NPL 2000-0123

March 10, 2000

DOCKETS 50-266 AND 50-301
TECHNICAL SPECIFICATIONS CHANGE REQUEST 219
ADOPTION OF PRESSURE AND TEMPERATURE LIMITS REPORT
AND REVISED P-T AND LTOP LIMITS
POINT BEACH NUCLEAR PLANT, UNITS 1 AND 2

DOCKETS 50-266 AND 50-301
TECHNICAL SPECIFICATIONS CHANGE REQUEST 219
ADOPTION OF PRESSURE TEMPERATURE LIMITS REPORT
AND REVISED P-T AND LTOP LIMITS
POINT BEACH NUCLEAR PLANT, UNITS 1 AND 2
DESCRIPTIONS AND BASES FOR PROPOSED CHANGES

Figure 15.3.1-2/PBNP Units 1 & 2
Cooldown Limitations Applicable to
23.6 Effective Full Power Years
(Approximately January 2001)

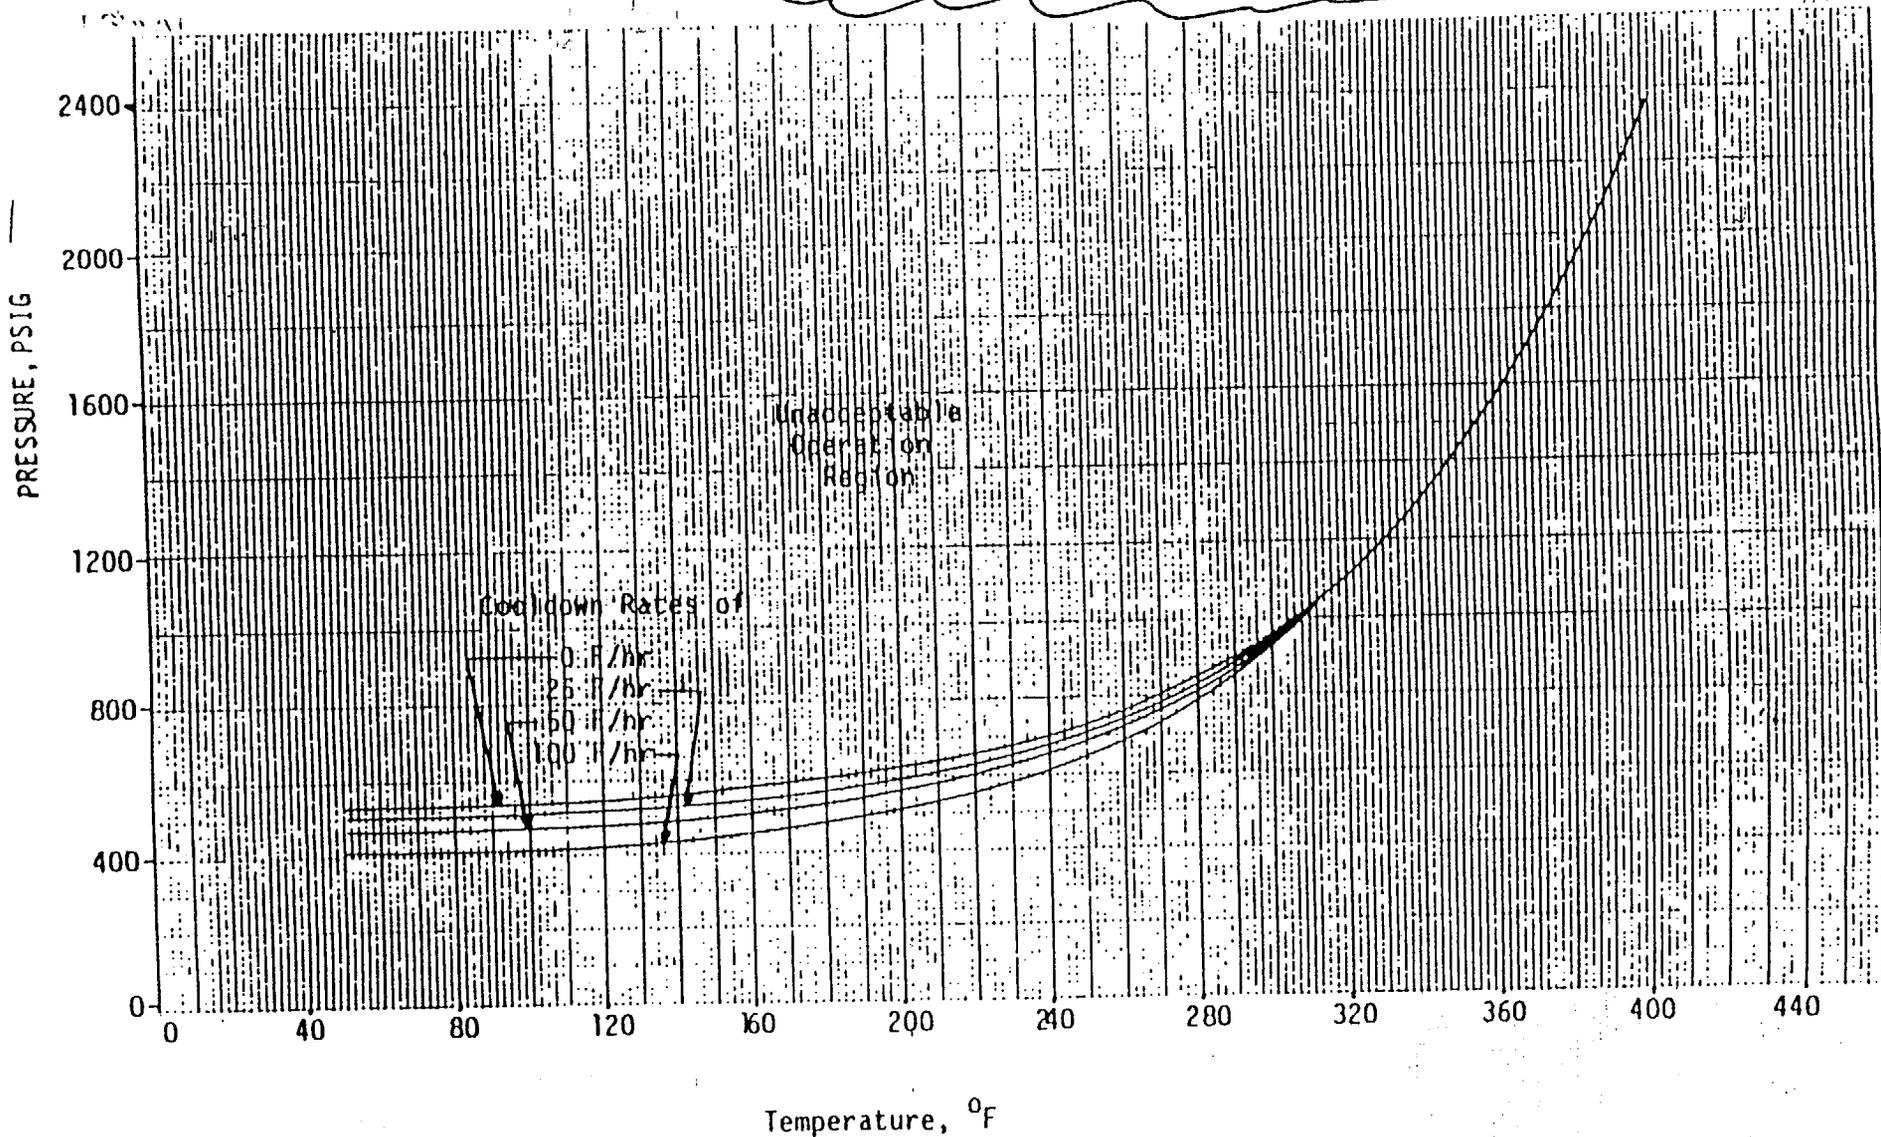
RELOCATE FIGURE
TO PTLR AND
CHANGE TO NEW LIMITS

Figure 15.3.1-1/PBNP Units 1 & 2
 Heatup Limitations Applicable to
 23.6 Effective Full Power Years
 (Approximately January 2001)

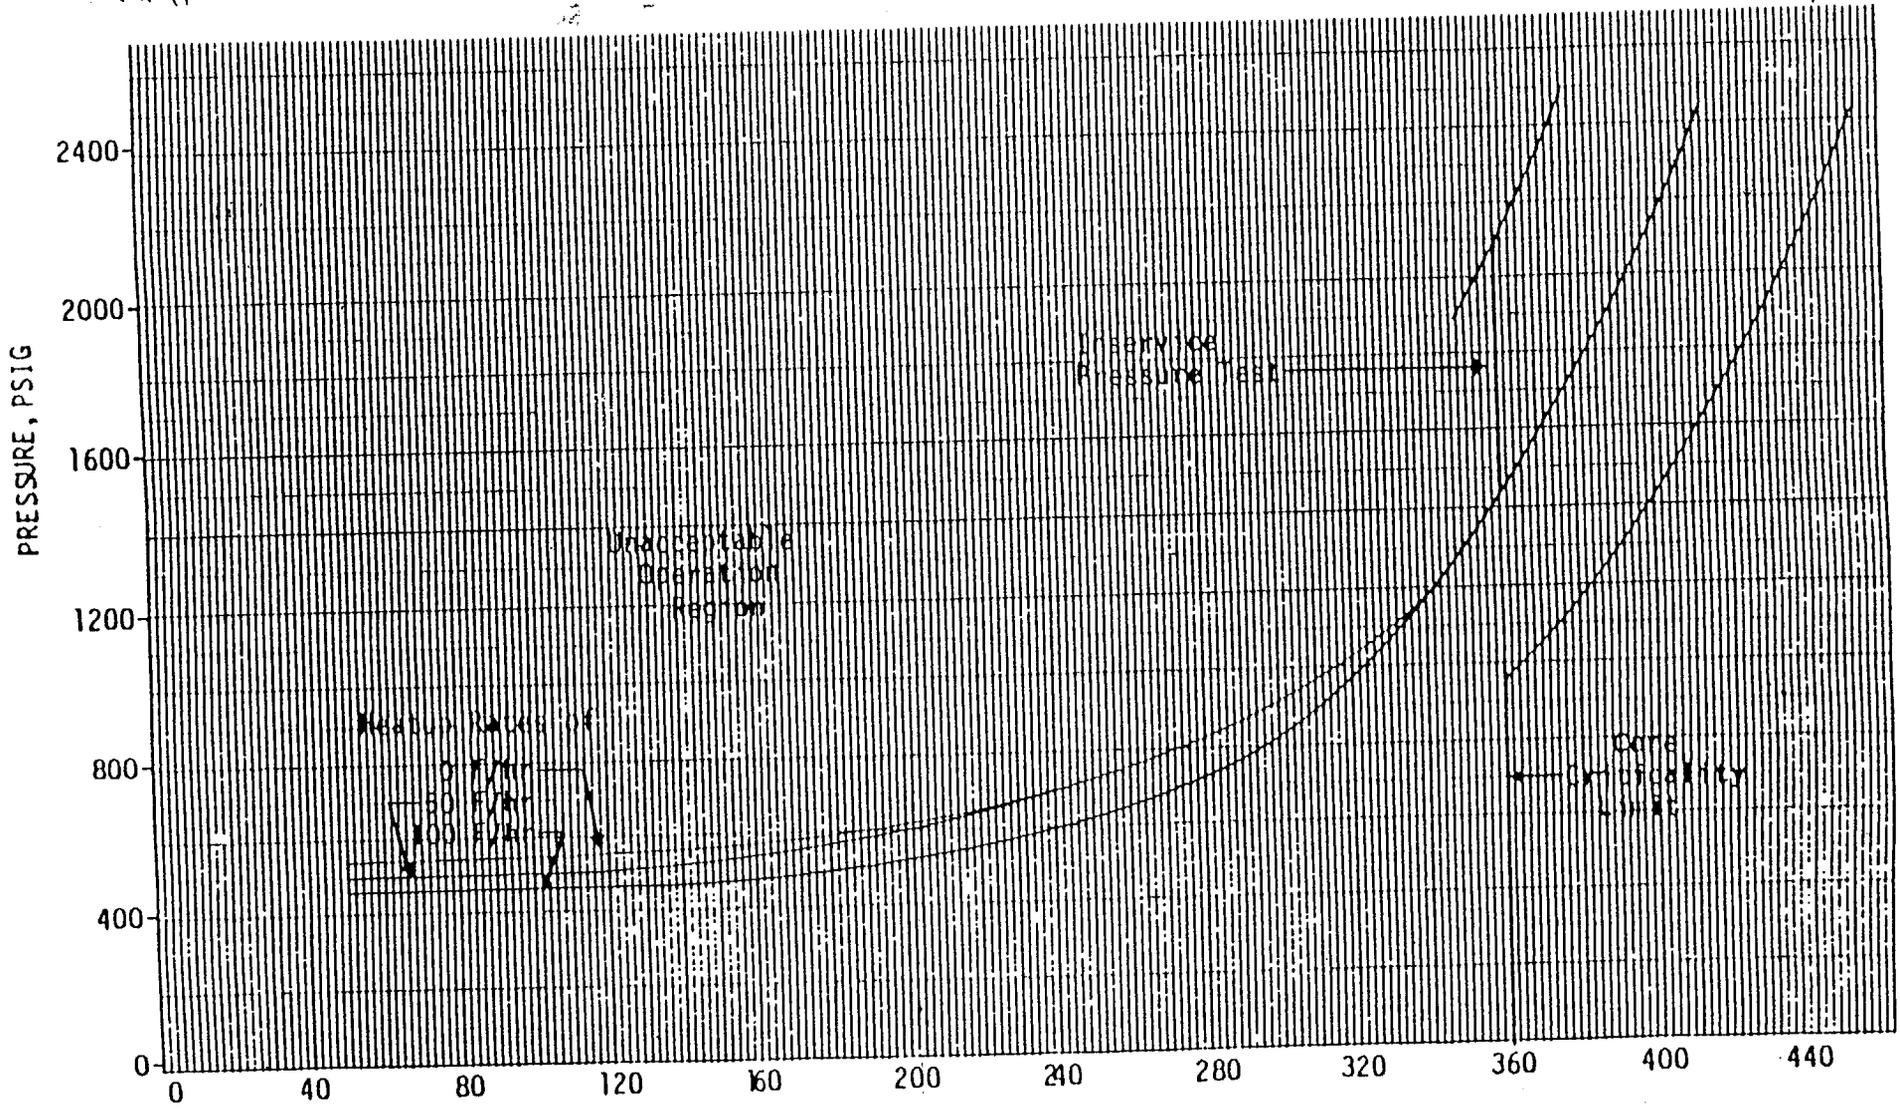
RELOCATE FIGURE
 TO PTLR AND
 CHANGE TO NEW LIMITS
